Access Compliance Report Public Rights-of-Way (Curb Ramps)

Main Street: CHARDONNAY_DR Cross Street: SAUVIGNON_DR Location: NE

ADA ID: RPAT211103110248 Ramp Type: Type 4 - Parallel Initial Pass/Fail: Fail Overall Compliance: No Severity Score: 2

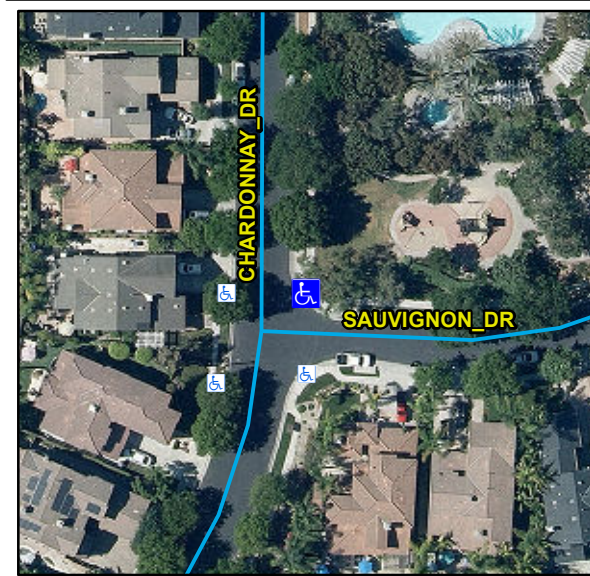
Compliance	Description	Data	Compliance	Description	Data
N/A	Ramp Length LT (in)	110	N/A	Ramp Length RT (in)	112
Yes	Ramp Width LT (in)	54	Yes	Ramp Width RT (in)	54
Yes	Ramp Run Slope LT (%)	7.5	Yes	Ramp Run Slope RT (%)	0.5
No	Ramp Cross Slope LT (%)	2.7	No	Ramp Cross Slope RT (%)	4.2
N/A	Landing Present	N/A	N/A	DWS Provided	N/A
N/A	Landing Length (in)	N/A	N/A	DWS Contrast	N/A
N/A	Landing Width (in)	N/A	N/A	DWS Length (in)	N/A
N/A	Landing Run Slope (%)	N/A	N/A	DWS Full Width	N/A
N/A	Landing Cross Slope (%)	N/A		DWS Offset Type	N/A
N/A	Landing Movement Obstructed?	N/A	N/A	DWS Offset Left (in)	N/A
	Landing Movement Type	N/A	N/A	DWS Offset Right (in)	N/A
N/A	Landing Shared	N/A			
N/A	Clear Space	Yes			
N/A	Clear Space To Crosswalk (in)	N/A			
N/A	Marked Crosswalk 1	No	N/A	Marked Crosswalk 2	No
	Crossing 1 Direction	NW		Crossing 2 Direction	SW
	Marked Crosswalk 1 Width (in)	N/A		Marked Crosswalk 2 Width (in)	N/A

Remove & Replace Curb Ramp With Two New Directional Ramps or Equivalent.
